**Amendments to the Drawings:**

### **REMARKS/ARGUMENTS**

Fig. 1

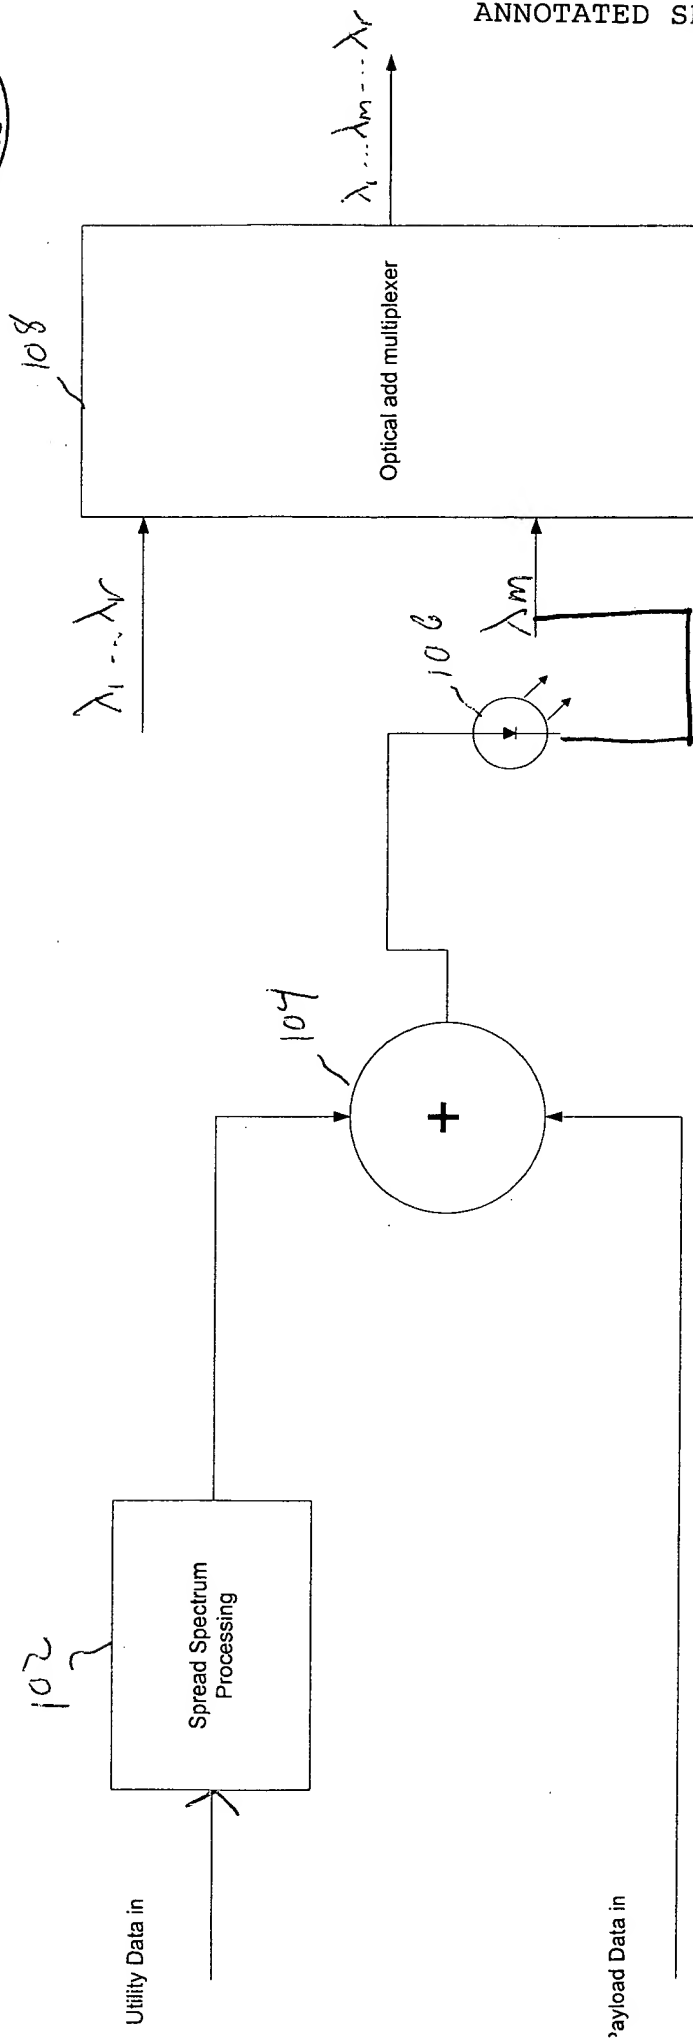
The attached sheets of drawings include some aesthetic changes to Figs. 1-5 and substantive changes to Fig. 1. These sheets, which include Fig. 1-5 and new Fig. 6, replaces the original sheets including Figs. 1-5.

Furthermore, a set of replacement drawings is hereby submitted to replace the original drawings for Figs. 1-5. The new drawings replace the reference numerals which were marked by hand and ensure that the drawings are correctly sized. Some minor changes were also made for aesthetic purposes. Also, in Fig. 1 a connection has been made to fill the inadvertent gap between the laser 106 and the optical add multiplexer 108.
